# ARAPAHO ROAD - PHASE III

FROM SURVEYOR BOULEVARD TO ADDISON ROAD

PROJECT RECORD COPY I

**COVER PLATE DETAIL**

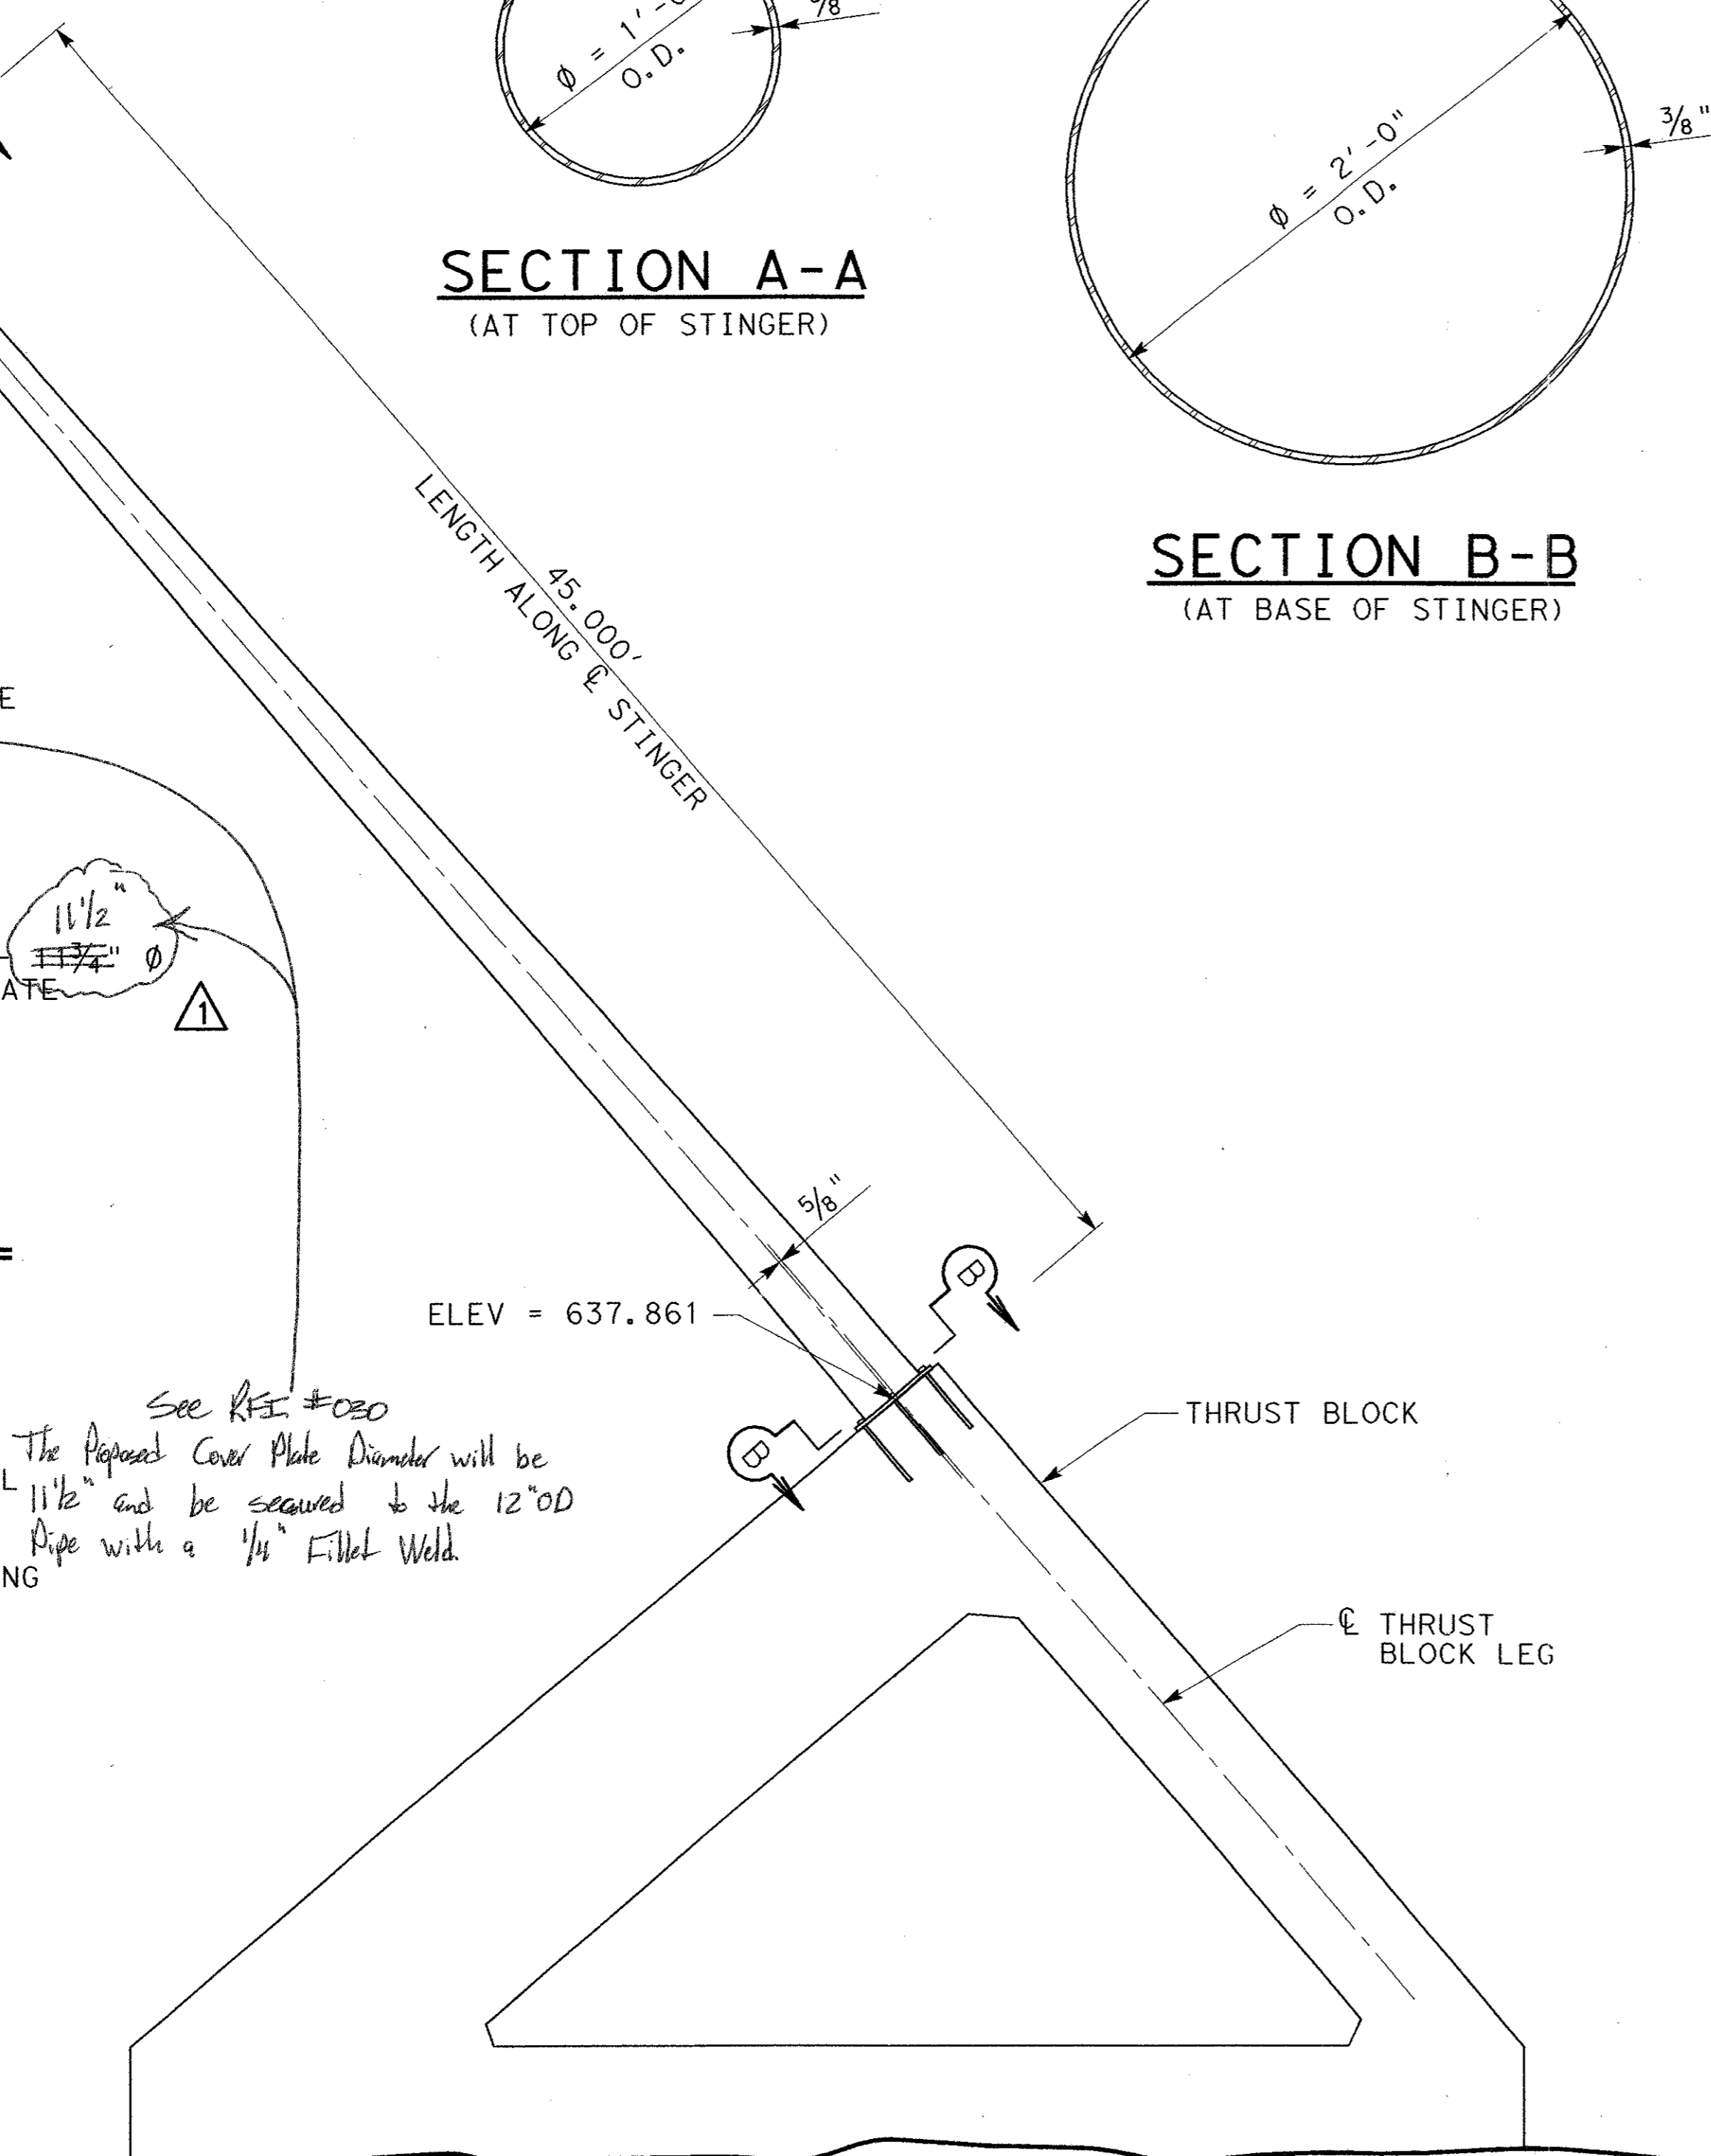
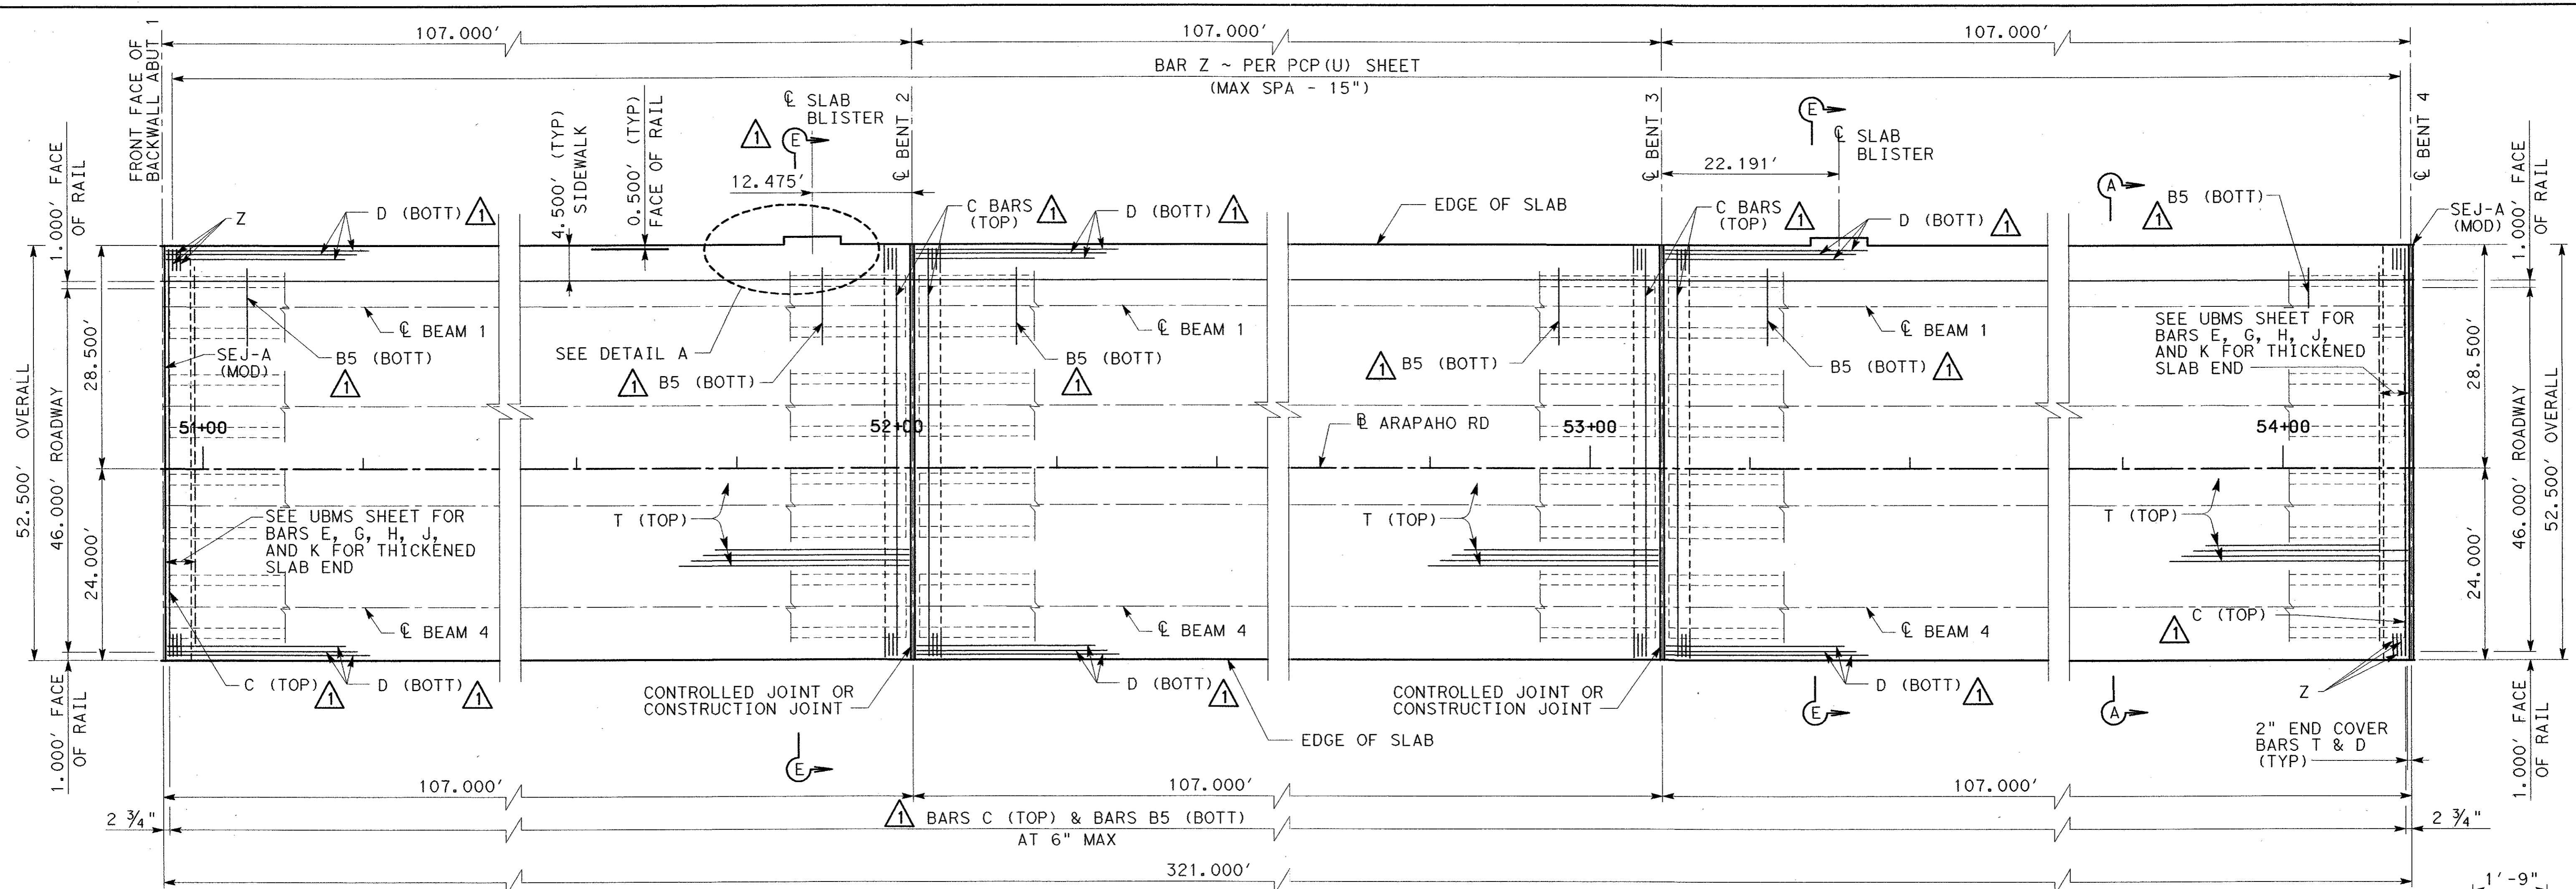
See RFI #020  
The Proposed Cover Plate Diameter will be 1 1/2" and be secured to the 12" OD Pipe with a 1/4" Fillet Weld.
